Project: Westpoint Harbor – **PHASE 2** Boatyard
(BCDC permit No: 2-02)
DES Project No. 9970.001

Subject: Permit Amendment Request

EXHIBIT A

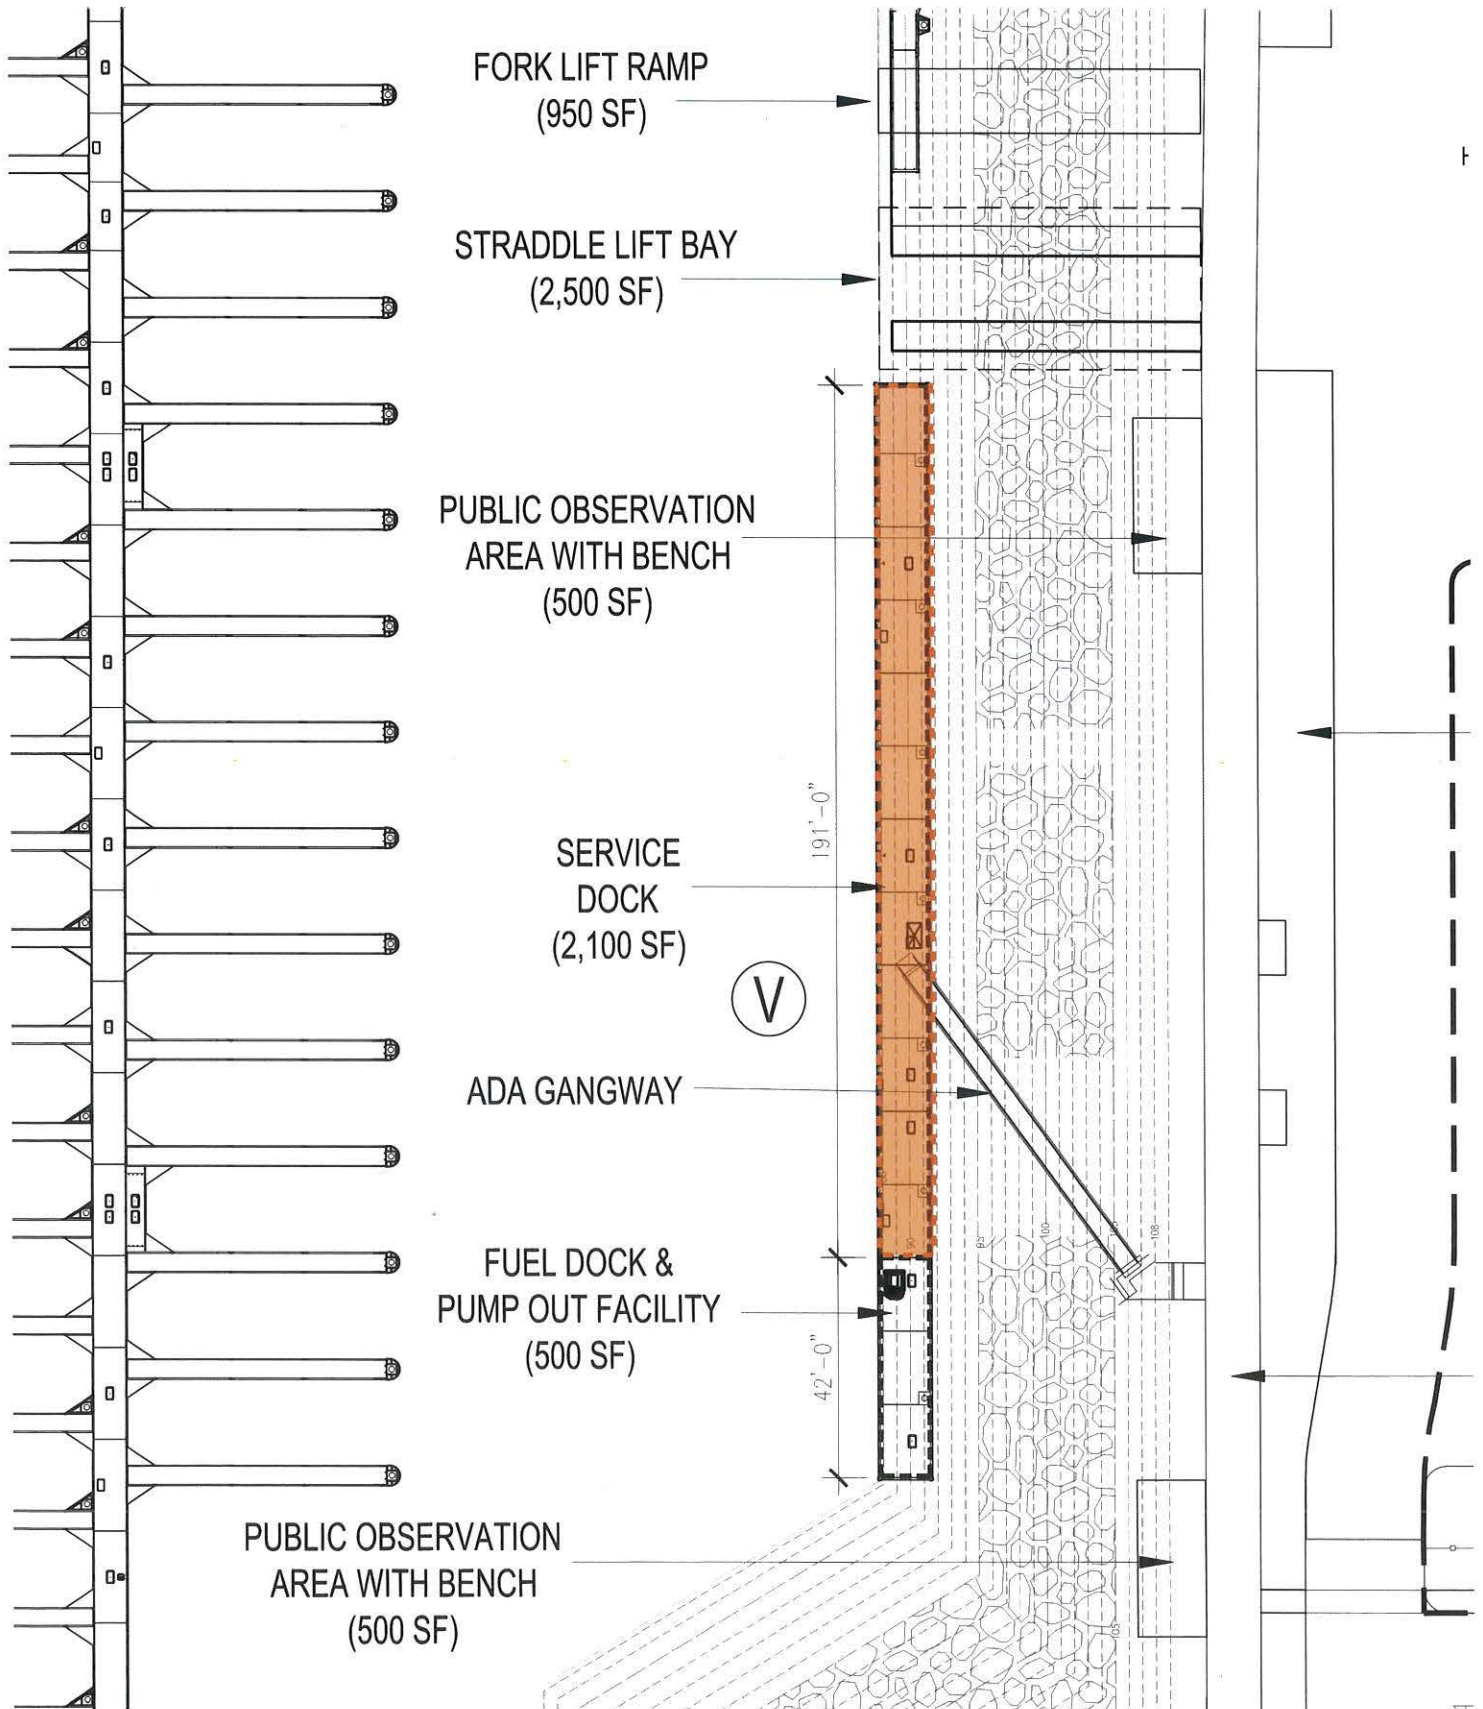
The boatyard service dock 'V', as shown on the attached **Exhibit A**, is 2,600 SF in total area and includes a 500 SF section fitted with fuel management and spill prevention facilities. The 2003 permit plans show the fuel dock as part of the 1000' transient dock (N and P) at the west side of the marina. Amendment 3 moved the fuel dock to the east side of the harbor for safety reasons, and the revised permit plans show the fuel dock as part of the boatyard service dock. (This is for obvious reasons: a 500 SF fuel dock 10' wide would only be 50' long. This is too short to tie up most boats in the harbor, and would not allow boats to queue up for fuel or pumpout).

The text of the current permit only lists the "500 SF fuel dock and pump-out facility", although the attached legal description and plans include the full service dock. We request a Permit Amendment to comprehend the service dock and make text and drawings consistent as follows:

2. *"Construct, maintain and use a 2,600 SF boatyard service dock which includes a 500 SF section for fueling and pumpout facilities".*

WESTPOINT MARINA & BOATYARD
LAUNCHING RAMP PLAN & DETAILS
REDWOOD CITY, SAN MATEO COUNTY, CALIFORNIA

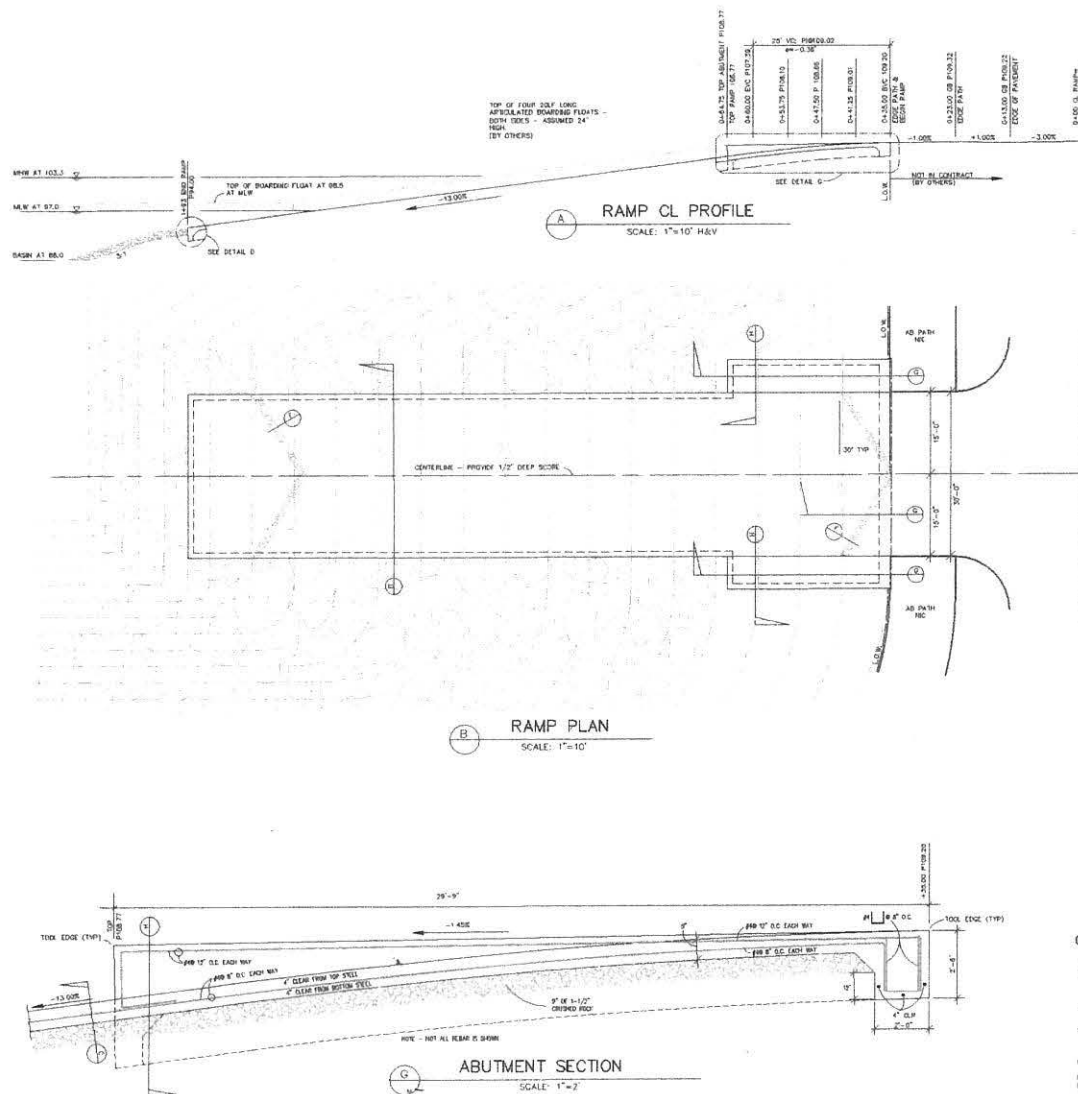
Amendment No. 3 of the permit authorizes a "2,160 square foot, two-lane, public boat launch ramp". In fact the total launch ramp area is 3,600 SF including abutments.

The two-lane launch ramp is designed in accordance with the California Division of Boating and Waterways *"Layout, Design and Construction Handbook for Small Craft Boat Launching Facilities"*, and is 30' wide and 120' from toe to the hinge point for a total area of 3,600 sf. (See attached **Exhibit B** - Construction Document sheets dated 10/23/06 for details of the existing launch ramp). Plans attached to the original permit and amendment 3 also show 3,600 SF, as do the 2003 DRB Staff Report plans and final dock construction drawings approved in 2007. Finally, the legal instrument filed with San Mateo County and attached to amendment 3 shows 3,600 SF.

"Construct, use and maintain an approximately 3,600 SF two-lane public launch ramp, 2,160 SF of which is within the 103.0 contour".

EXHIBIT C1

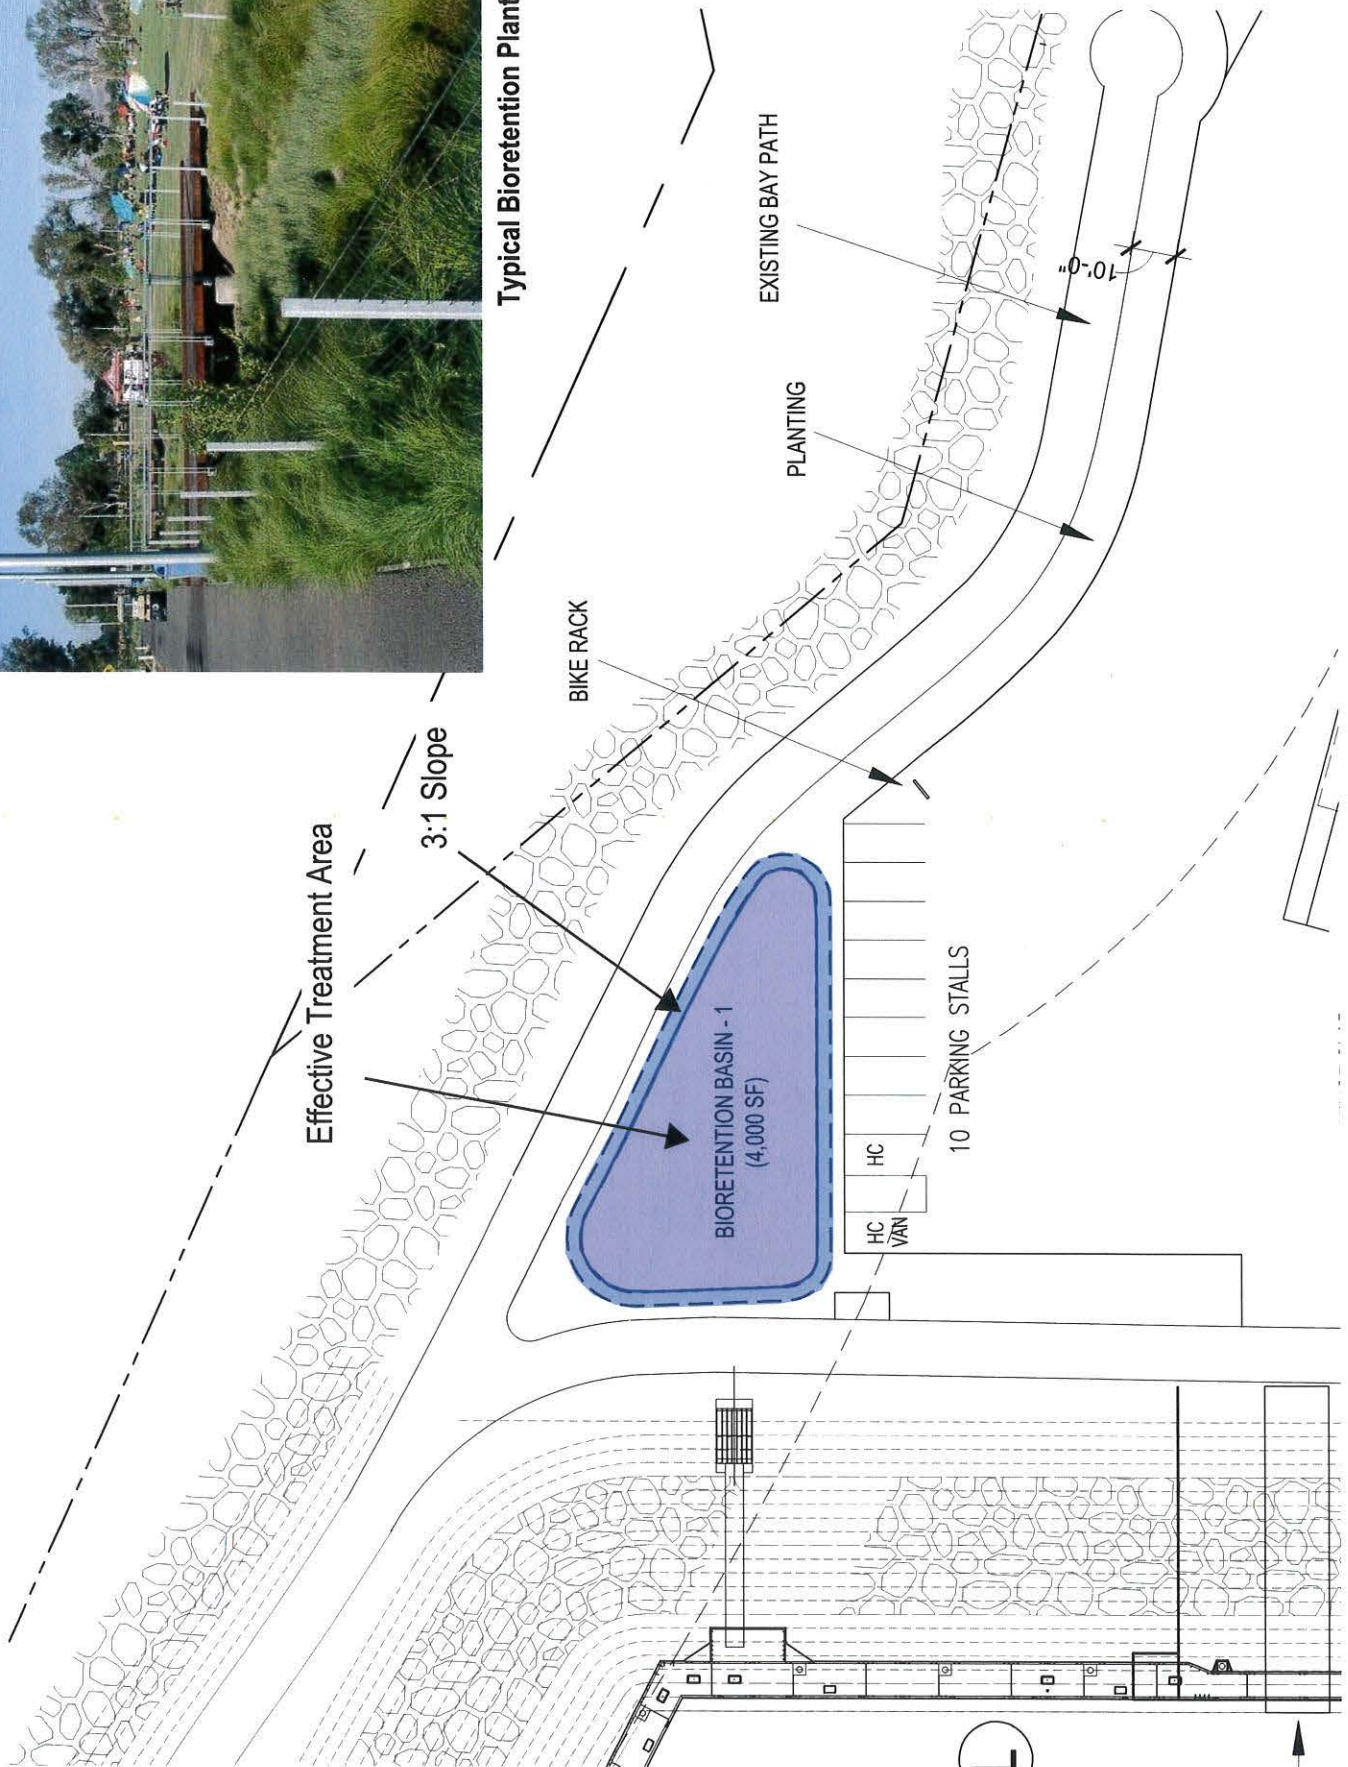
The permit does not specifically authorize bio-retention ponds.

The permit includes conditions for protection of water quality, and requires the permittee to conform to Regional Water Quality Control Board requirements for storm water management. In addition to bioswales included at the time the permit was issued, current RWQCB requirements include two bio-retention basins to treat storm water in the Phase 2 site area. The basin in the north east corner of the site (1) is approximately 4,000 SF and the basin to the east of the site (2) is approximately 3,950 SF. These basins meet current state requirements for the treatment of on-site stormwater. Suggested language to align RWQCB and BCDC authorization:

Note: The proposed Bioretention basins are shown on sheets 4, 5, C1 and C2 of the Plan Review Submittal dated May 12, 2015, copy attached for your reference. The attached **Exhibits C1 and C2** shows an enlarged plan for each basin with the proposed approximate SF.

5. *“Construct, use and maintain storm water runoff management systems as required by the RWQCB including two bio-retention basins of approximately 8,000 SF in total”.*
